Proposed modifications to section 9.3 shown below

9.3 The stratified event scheduler

<NEW FIG 9.1>

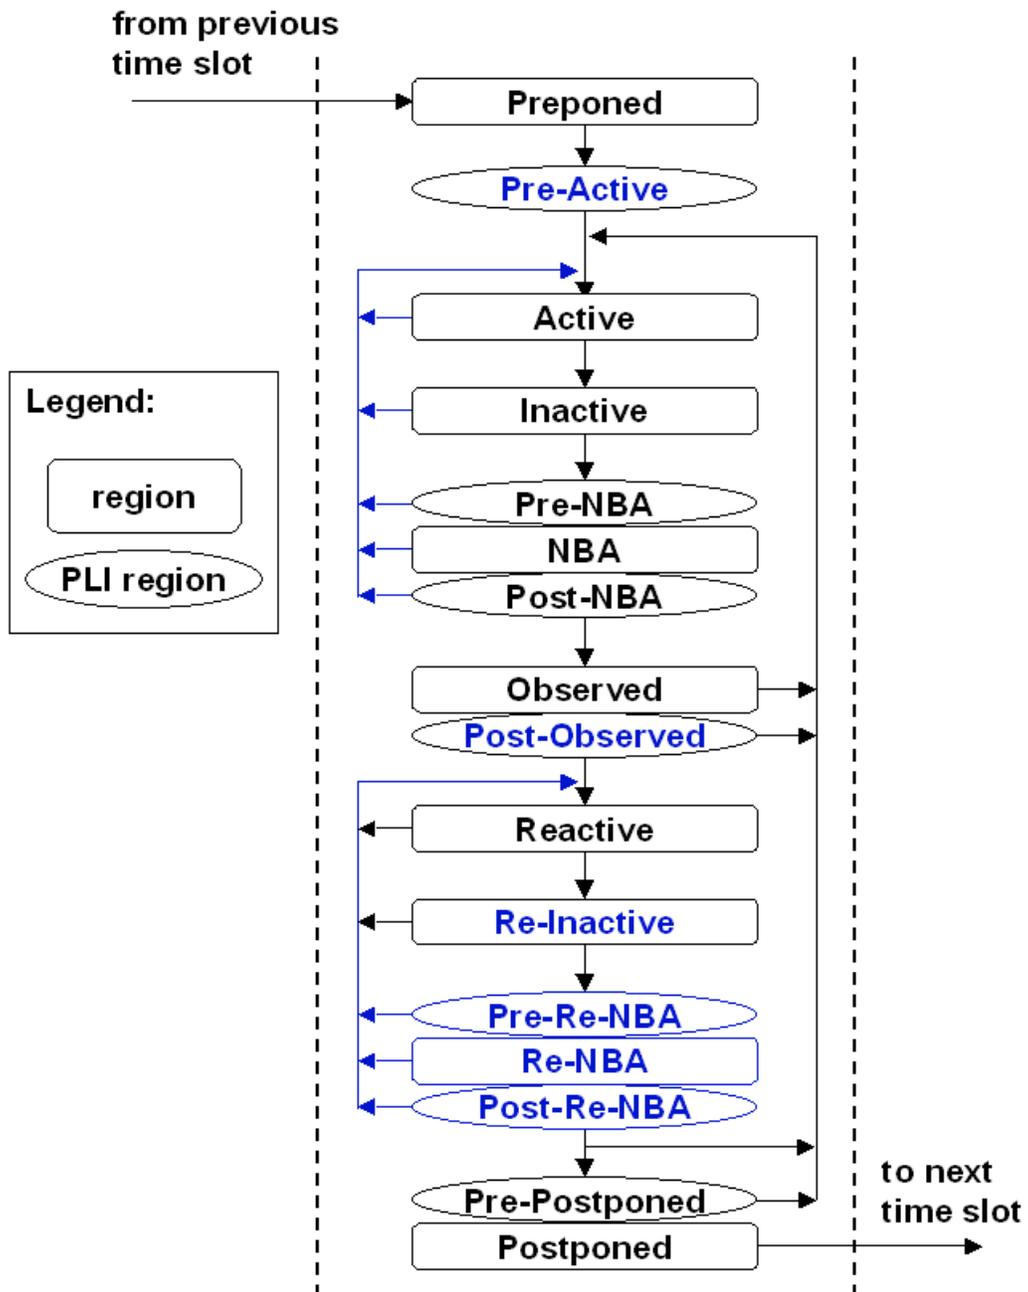
The simulation regions of a time slot are the Active, Inactive, NBA, Observed, Reactive, Re-Inactive, Re-NBA and Postponed regions. The flow of execution of the event regions is specified in Figure 9-1.

In addition to the simulation regions, where PLI callbacks can be scheduled, there are additional PLI-specific regions. The PLI regions of a time slot are the Preponed, Pre-Active, Pre-NBA, Post-NBA, Post-Observed, Pre-Re-NBA, Post-Re-NBA and Pre-Postponed regions. The flow of execution of the PLI regions is specified in Figure 9-1.

The **Pre-Postponed** ~~Pre-postponed~~ region provides a PLI callback control point that allows PLI application routines to read and write values and create events after processing all other regions except the Postponed region. The flow of execution of the event regions is specified in Figure 9-1.
